**Re: GE-Pittsfield/Housatonic River Site
Silver Lake Area (GEC600)
Revisions to Pre-Design Investigation Report for Silver Lake Sediments**

This letter has been prepared in response to the Environmental Protection Agency's (EPA) November 30, 2004 conditional approval letter related to the September 2004 *Revised Pre-Design Investigation Report for Silver Lake Sediments* (PDI Report). Provided below is a discussion of General Electric's (GE) responses to EPA's November 30, 2004 comments. For convenience, EPA comments are provided in italics, followed by GE's response in standard format. Where EPA comments require revisions to the PDI Report, those revisions are described in the GE responses and are implemented in the attached documents. Specifically, we are providing replacements for the following portions of the PDI Report:

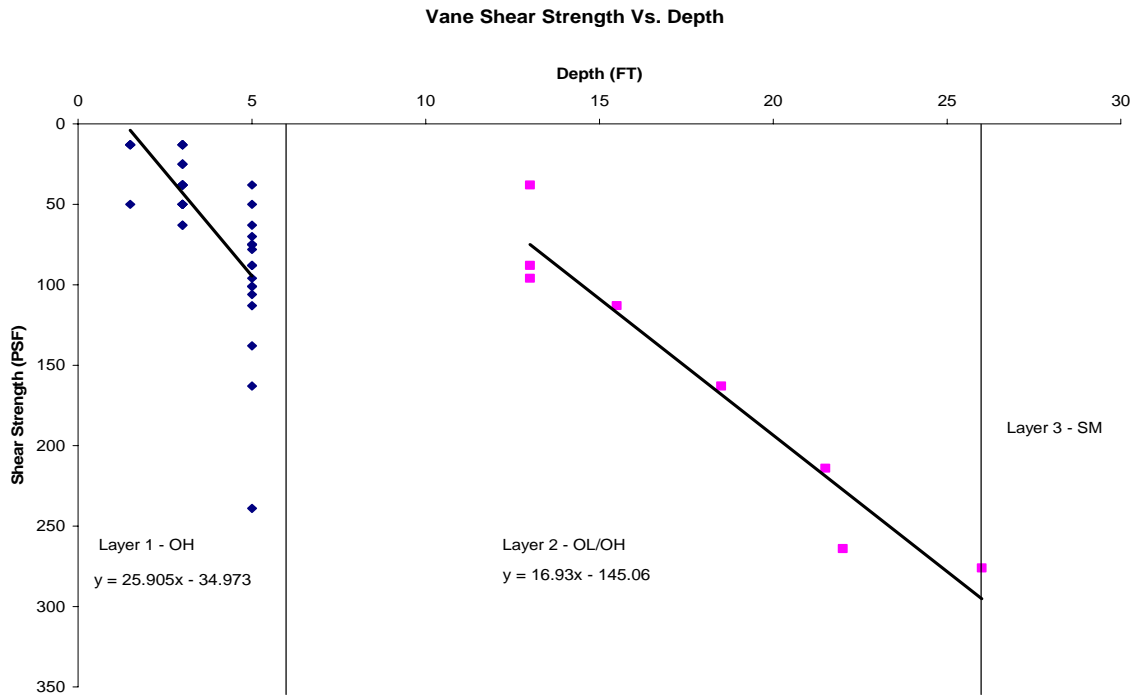
4. **Page 2-34:** *The equations for the Vane Shear vs. Depth data for the soil layers 1 and 2 presented on the plots express the independent variable (i.e., Depth, the "y" coordinate) as a function of the dependant variable (i.e., Undrained Cohesive Shear Strength of the sediments, the "x" coordinate). It is more appropriate if these variables are reversed, that is, the undrained cohesive shear strength of the lake bottom sediments should be expressed as a function of depth in the linear regression equations. GE shall revise the plot accordingly.*

Response 4: As requested, the in-text figure on Page 2-34 has been revised such that the undrained cohesive shear strength of Silver Lake sediments (the "y" coordinate) is expressed as a function of depth (the "x" coordinate).
